Questions & Answers

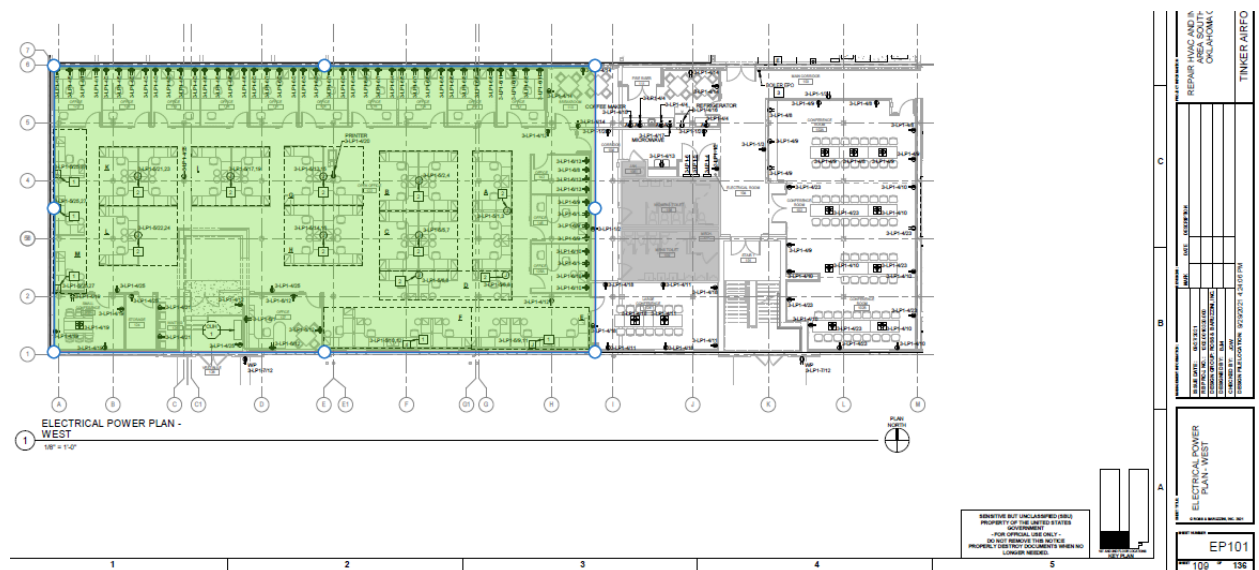
- 6) The SOW states there is to be an adjustable height main desk, 24 x 47, but the plan in the Electrical_IFC Submittal pdf (shown below) shows a cockpit corner surface which would be 36x36, so the adjacent surfaces would be 24x36 to make the 6’ x 6’. Please clarify the configuration of tops/panels widths/depths. The workstation looks like a 6’x8’ on the plan.

The above furniture picture is from the AutoCAD plan that was provided in response to previous RFIs. It was created by the A&E that is doing the construction in the area currently. That plan was provided for the contractor to use for their own drawing and measurement purposes only. This furniture layout does NOT match what is being requested in this RFP. The furniture contractor shall reference the attachment 9B_B3 Layout that was provided in the RFP package, which includes 6’x6’ cubicles.
